DART SERVICE INSTRUCTION

TO AMEND INSTALLATION INSTRUCTIONS IIN-D205-594 Rev. C (AND EARLIER) AND
INSTRUCTIONS FOR CONTINUED AIRWORTHINESS ICA-D205-594 Rev. 2 (AND EARLIER)
REF. CANADIAN STC: SH03-6
REF. FAA STC: SR01742NY

B	REPLACE MS21920-24 WITH MS21920-25 ON -101/-105; ADDED EXTRA NOTE TO INSTALLATION PROCEDURE (STEP 7)	MB	07.12.04
A	NEW ISSUE	MB	07.11.16
REV.	DESCRIPTION	BY	DATE
DESIGN		DART AEROSPACE LTD HAWKESBURY, ONTARIO, CANADA DRAWING NO. _____ REV. B DSI 9396 SHEET 1 OF 2 TITLE _____ SCALE _____ CROSSTUBE SUPPORT CHANGE NTS	
DRAWN			
CHECKED			
MFG. APPR.			
APPROVED			
DE APPR.			
DATE	07.12.04		
COPYRIGHT © 2007 BY DART AEROSPACE LTD THIS DOCUMENT IS PRIVATE AND CONFIDENTIAL AND IS SUPPLIED ON THE EXPRESS CONDITION THAT IT IS NOT TO BE USED FOR ANY PURPOSE OR COPIED OR COMMUNICATED TO ANY OTHER PERSON WITHOUT WRITTEN PERMISSION FROM DART AEROSPACE LTD.

FIGURE 1: INSTALLATION OF SUPPORT ON CROSSTUBE

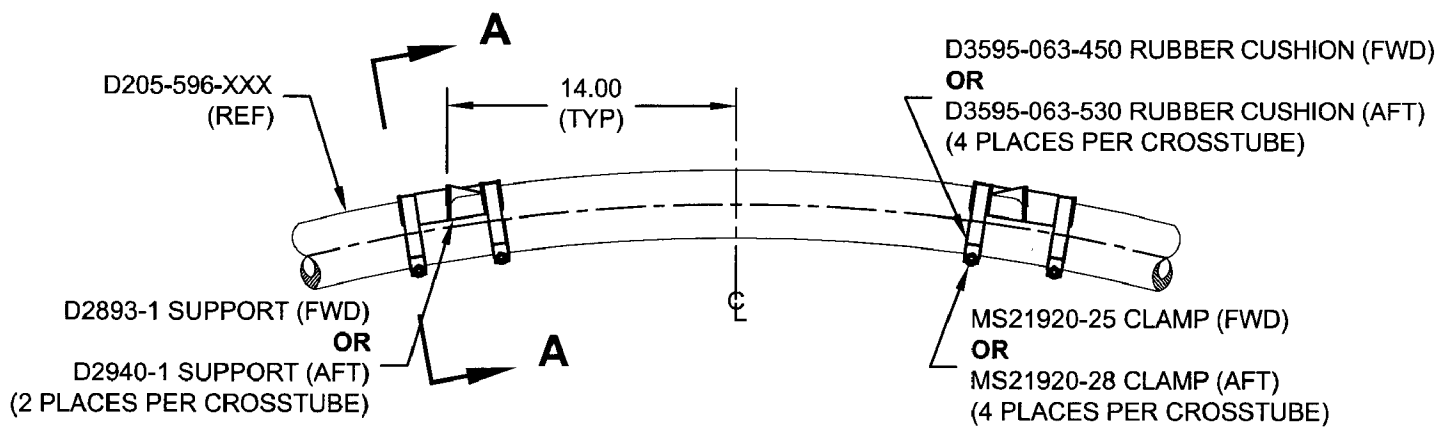
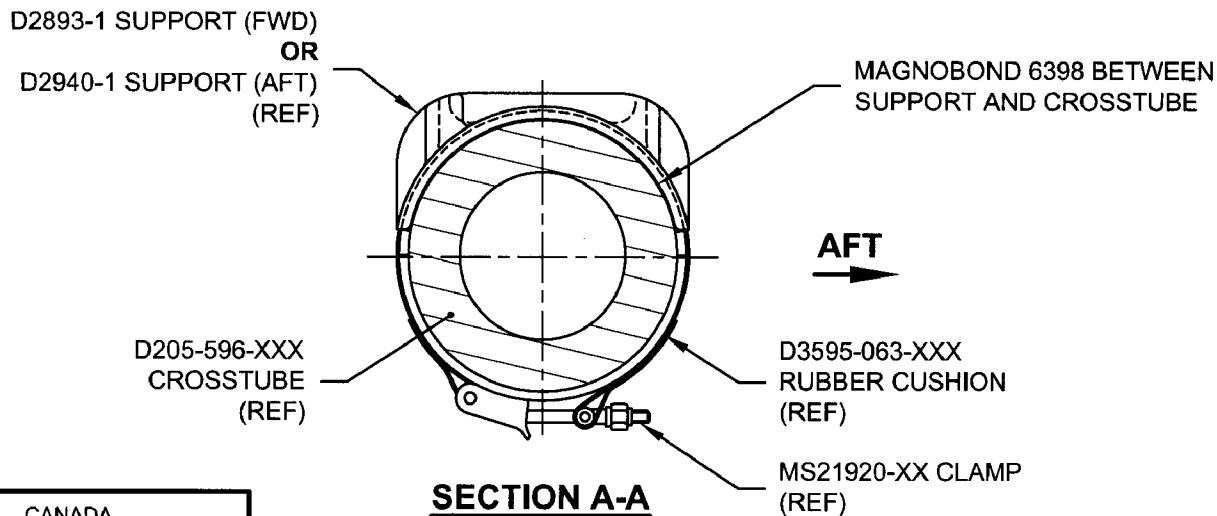
To prevent the supports from shifting on D205-596-101/-103/-105/-107 Crosstubes at CHG 001, the D2893-1 or D2940-1 Supports should be removed and re-installed as follows:

- Apply a 0.03" to 0.06" thick layer of Magnobond 6398 underneath D2893-1 or D2940-1 Supports and re-install the Supports on the crosstube as shown in Figure 1. Install a D3595-063-450/-530 Rubber Cushion on each MS21920-25/-28 Clamp. Position and secure the D2893-1 or D2940-1 Supports on the crosstube using MS21920-25/-28 Clamps. Torque clamps to 80-100 in-lb. Let the D205-596-101/-103/-105/-107 Crosstube Assembly cure before re-installing the crosstube on the aircraft.
Note: It is acceptable to substitute the MS21920-25/-28 with longer or shorter clamps to accommodate varying diameters. Ensure there is a minimum of 1.5 threads in safety on the nut.
